CAIRNGORMS NATIONAL PARK AUTHORITY

Title: REPORT ON CALLED-IN PLANNING APPLICATION

DEVELOPMENT PROPOSED: FULL PLANNING PERMISSION FOR ERECTION OF CLUBHOUSE (AMENDED PLANS), SITE OF PROPOSED GOLF CLUBHOUSE, DALFABER VILLAGE, DALFABER DRIVE, AVIEMORE

REFERENCE: 08/084/CP

Fig. 5. Elevations – Previous Proposal

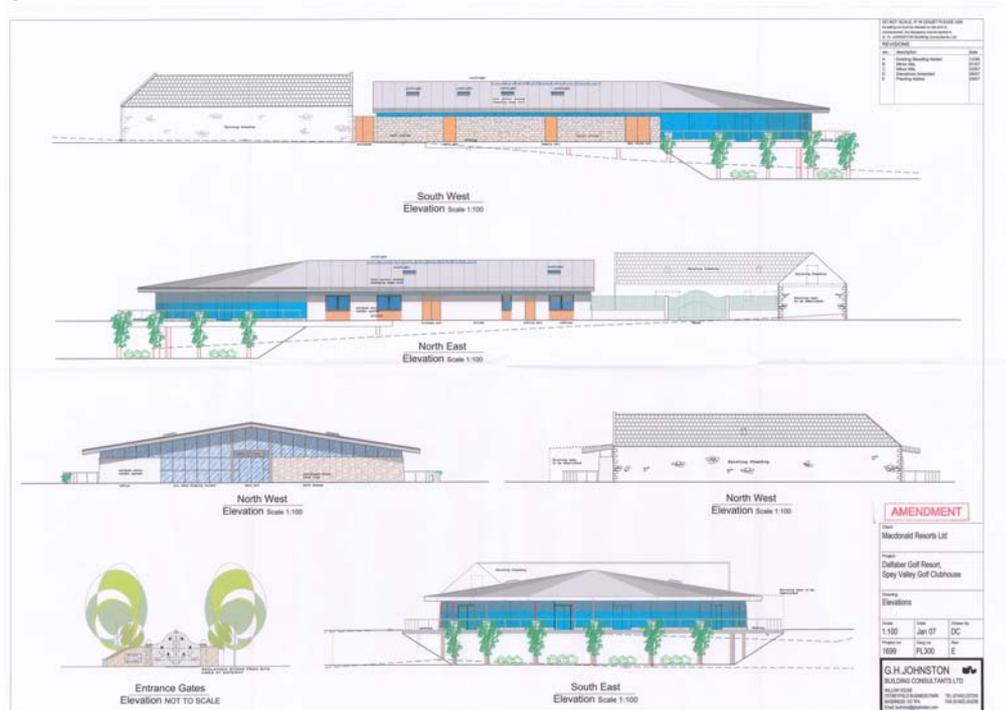
4. The previous approved proposal included a permanent change of use of the existing steading building for golf buggy storage purposes but also a new building immediately adjacent on the south east side. This accommodated a bar/restaurant with related stores and kitchen areas, a “pro” shop, office, and male and female changing, shower and toilet facilities. This new building took a single storey form with curved glazed frontage

with outdoor decking, taking advantage of the elevated views over the golf course. Materials included zinc colour coated standing seam roof (with some rooflights), glazing, stone reclaimed from the site, white wet dash render, and some timber panels. The curved glazed frontage extended above the ground levels which slope down to the golf course and this area was supported by columns. Planting was indicated on the decking area. The juxtaposition of the two buildings created a courtyard area which was enclosed by a wall and railings with a gate.

5. The applicant's have re-appraised the extent of the proposed development and now wish to progress with a more modest building. It is similar in design concept to the previous one but is much smaller in size and scale. The accommodation provided is similar to that previously proposed and includes a bar/restaurant with associated food preparation area, open plan meeting space/pro shop, and male and female changing and toilet facilities. Materials are now proposed as aluminium standing seam roof, aluminium framed glazing to the curved frontage and timber cladding to the walls. A decked viewing area constructed on columns over the slope down to the golf course is still proposed and a central courtyard area is still being created between the new building and the existing steading. The

Fig. 13. Extant Permission Design from 2004

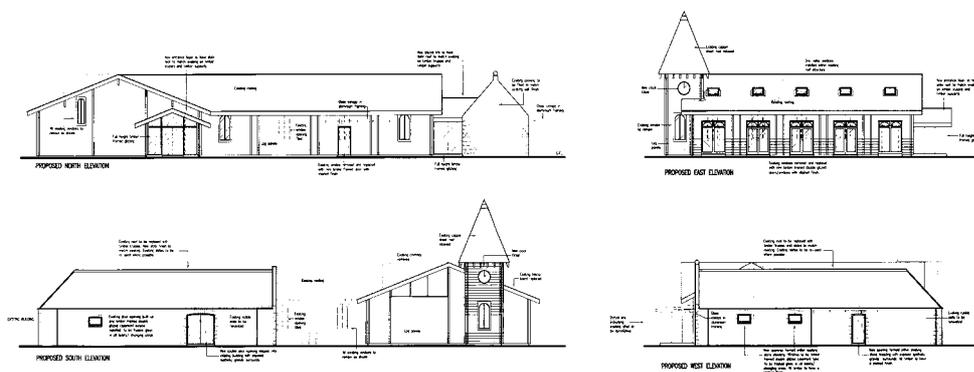
27. In my assessment on the previous application, the starting point was the design of the building approved under the 2004 permission. This comprised a pitched roof timber clad structure with a clock tower. It was in fact the former "Santa Claus" building from the Aviemore Resort which was to be relocated. This permission still remains extant and could be implemented at any time up until April 2009. It is not known though if this structure still exists. Nevertheless, my view previously was that the new design at that time must be seen in the context of this existing permission.
